APPLICATION NO.	FILING DATE	FIRST NAMED INVENTOR	ATTORNEY DOCKET NO.	CONFIRMATION NO.
10/577,007	04/24/2006	Franck Rolion	011348-0020-999	5989
20583	7590	12/16/2009	EXAMINER	
JONES DAY 222 EAST 41ST ST NEW YORK, NY 10017			VARNUM, RYAN A	
			ART UNIT	PAPER NUMBER
			3751	
			MAIL DATE	DELIVERY MODE
			12/16/2009	PAPER

Office Action Summary	Application No. 10/577,007	Applicant(s) ROLION ET AL.	
	Examiner RYAN A. VARNUM	Art Unit 3751

DETAILED ACTION

Annotated Partial Fig. 9A

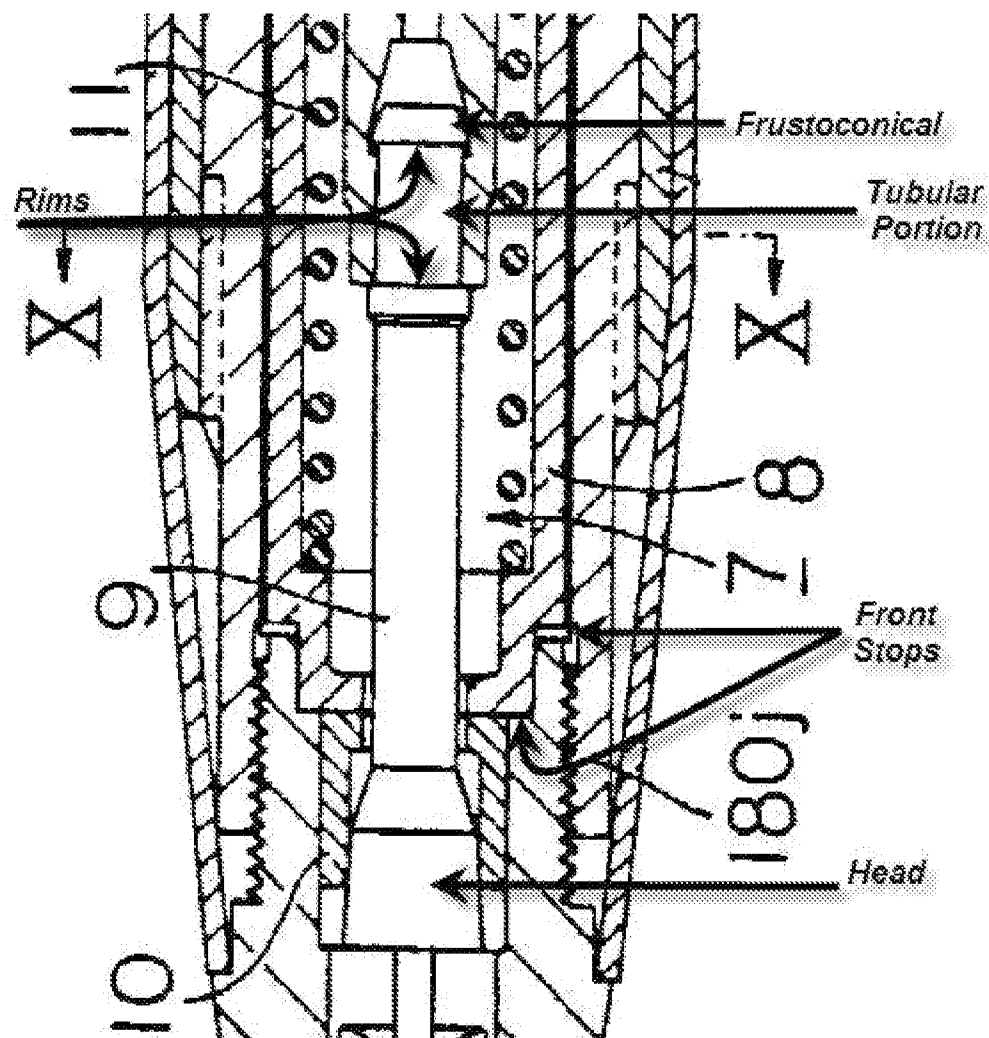
movable member 110 ("cassette adapter"; Fig. 9A; Column 10, Lines 13-15) having a forwardly oriented bearing surface ("forward end"; Fig. 9A; Column 10, Lines 25-28) and having a reservoir prolonged by a central duct (See Fig. 9A) allowing the passage of the leads one by one (Column 13, Lines 11-31); a chuck 9 (Fig. 9A; Column 10, Line 4) having a tubular portion connected to said movable member, in order to allow the passage of a lead from the central duct toward a head (See Annotated Partial Fig. 9A below) of said chuck, wherein said chuck is capable of being clamped on the lead (See Annotated Partial Fig. 9A below; Claim 1c); a clamping ring 10 ("chuck tightening ring"; Fig. 9A; Column 10, Line 19) which is movable longitudinally with respect to said chuck and to the tubular body and which is designed to cooperate with the head of said chuck (Column 15, Lines 16-21; Claim 1e); and an elastic element 11 ("resilient body"; Fig. 9A; Column 10, Line 25) having a front end and a rear end, wherein the rear end bears against the bearing surface of said movable member (Column 10, Lines 25-28; fig. 9A), said elastic element being designed to be a single element (See Fig. 9A, See Response to Arguments section below) which biases said clamping ring against the head of said chuck when said advancing mechanism is in a rest position (Claim 1h), a bush 8 ("sleeve"; Fig. 9A; Column 10, Line 20), movable longitudinally with respect to said chuck and the body (Column 10, Lines 20-23), arranged between said clamping ring and the front end of said elastic element (Fig. 9A; Column 10, Lines 20-28), wherein the body has a front stop (See Annotated Partial Fig. 9A below) designed to limit the forward displacement of the bush.

7. In re Claims 17 and 31, as discussed above in regard to Claim 1, the combination of Kageyama/Leistenschneider discloses all the claimed features, and Kageyama further discloses the front stop (See Annotated Partial Fig. 9A above) is formed by a radially inner rim which cooperates with a peripheral portion of the front end of the bush 8 (See Fig.'s 9A and 14; it being understood that the front stops being

10. In re Claim 20, Kageyama further discloses the tubular portion (See Annotated Fig. 9A above) of said chuck 9 (Fig. 9A) has a frustoconical portion (See Annotated Partial Fig. 9A above) extending from the first rim as far as the rear end of said chuck.

effect the desired result. Specifically, the "opening or closing mechanism 70" (Fig. 9A; Column 13, Lines 11-31) would be removed, in favor of substituting a length of piping extending from the "tubular portion" (See Annotated Partial Fig. 9A above) which would extend along the central duct and into the lead piece retaining section. Such modification would require only the duplication of the similar structure as disclosed in Leistenschneider and depicted in Fig. 1 as the portion of lead tube 9 extending upwardly from annular flange 32. It is the Examiner's opinion that this modification is made only more obvious by the fact the "opening or closing mechanism 70", which such modification would replace, is itself a structure which functions to prevent lead jamming (i.e. – "one lead can be moved through the groove"; Column 13, Lines 25-31).
